# PLAN OF PROPOSED IMPROVEMENT

## 3802 KIPP STREET

CITY PROJECT NO. 15017  
CONTRACT NO. 9496

#### Revision 1: (05/28/2024)

15017  
P-1

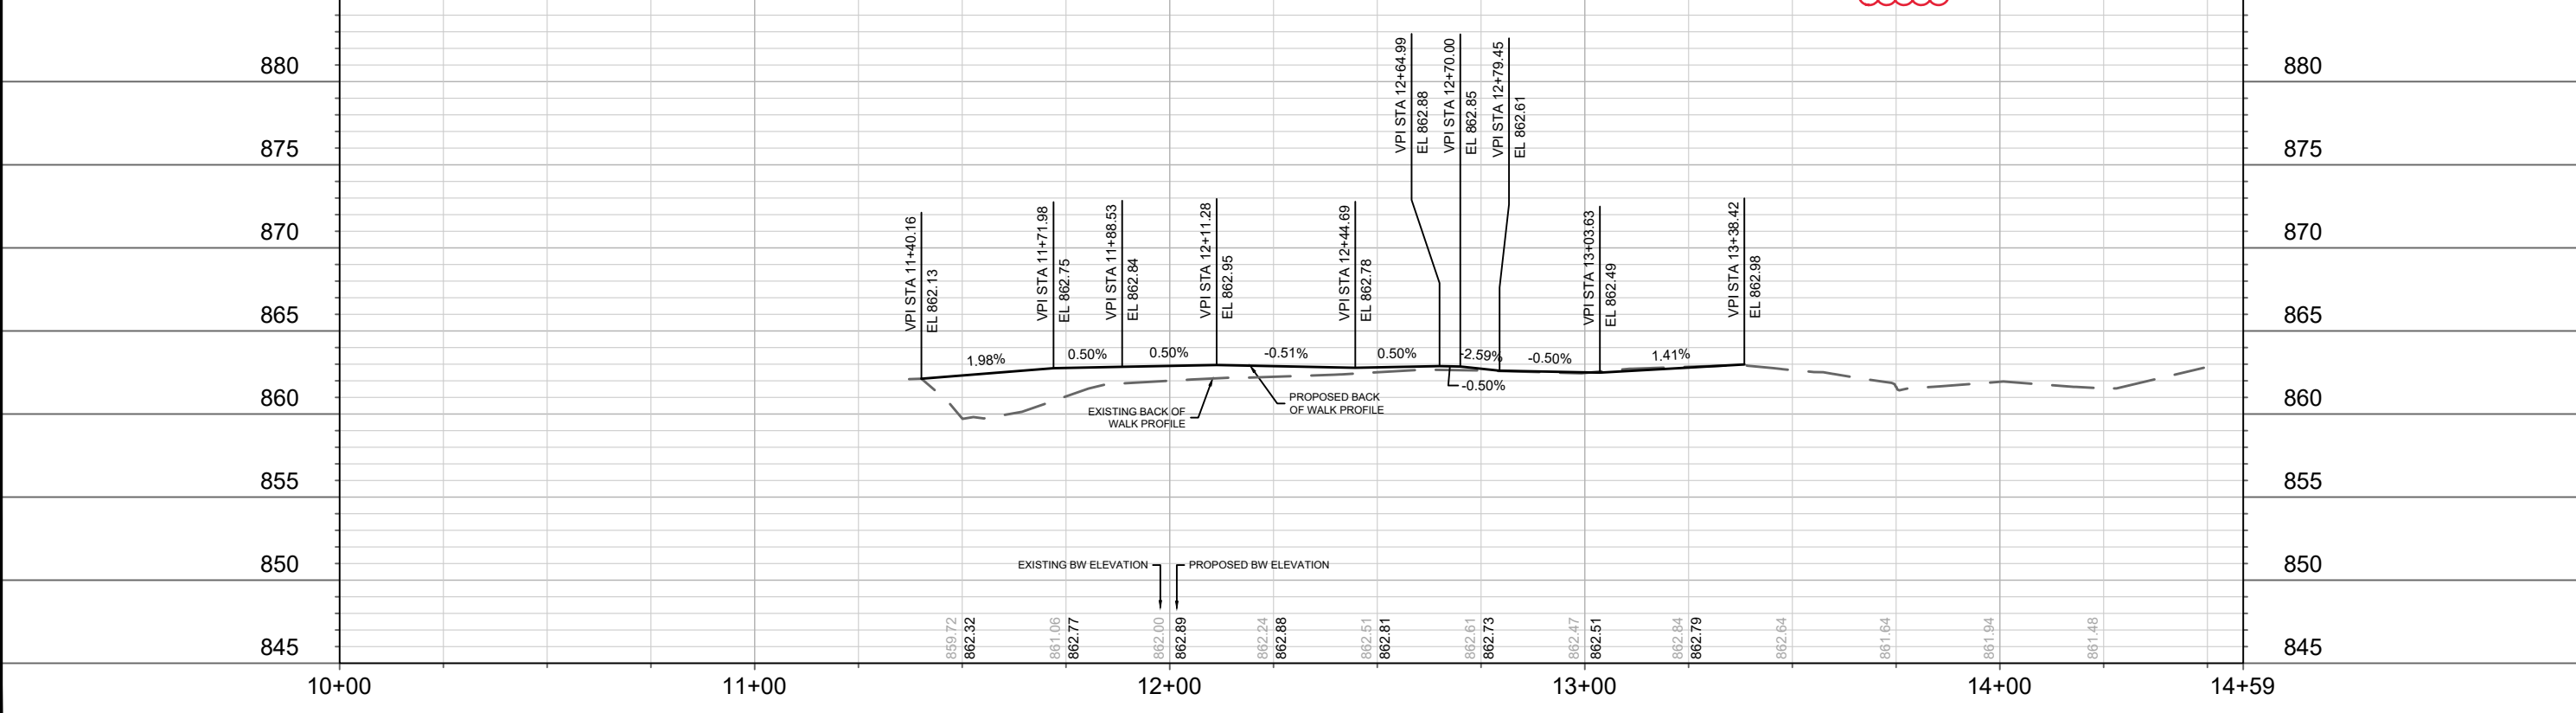
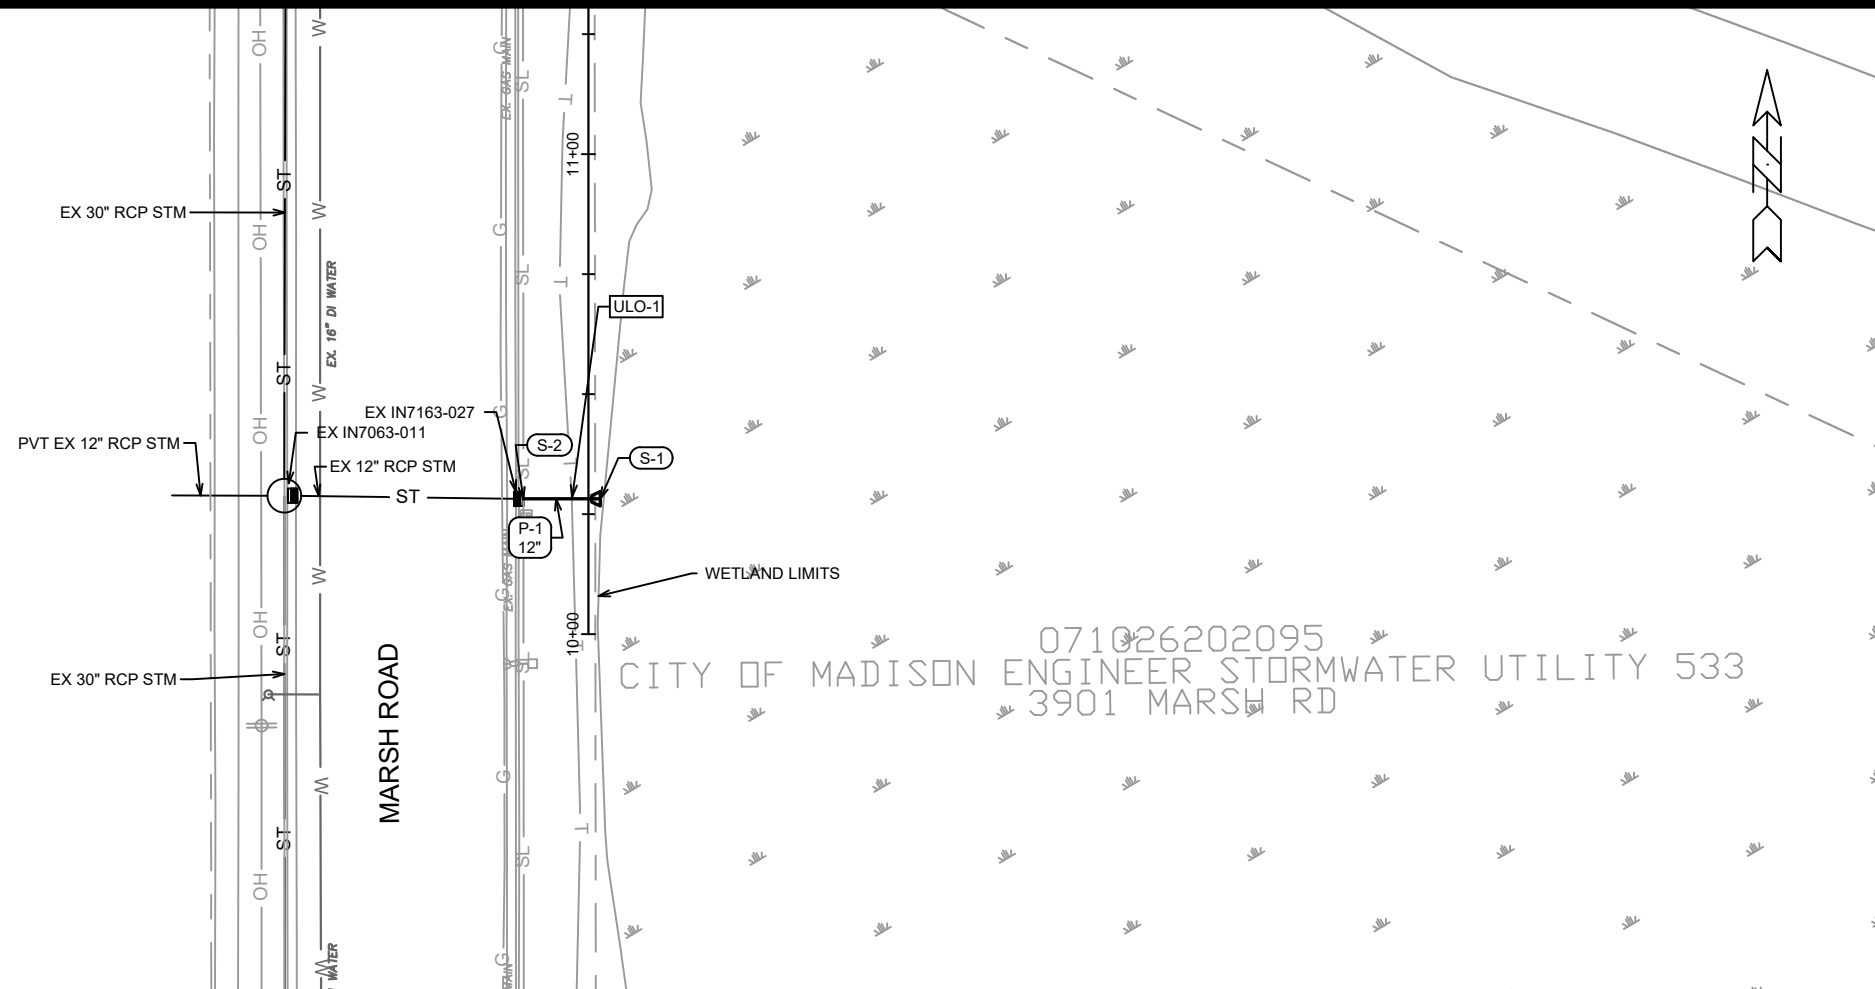
- P-1: Show location of sidewalk spot replacement for lateral connections, added two notes for sidewalk replacement and terrace restoration
- U-2: Show water service lateral connection

- NOTES**
1. REMOVE AND REPLACE TYPE 'A' CONCRETE CURB AND GUTTER
  2. LIMITS OF SIDEWALK REPLACEMENT TO BE DETERMINED BY CONSTRUCTION ENGINEER
  3. LIMITS OF TERRACE RESTORATION TO BE DETERMINED BY CONSTRUCTION ENGINEER
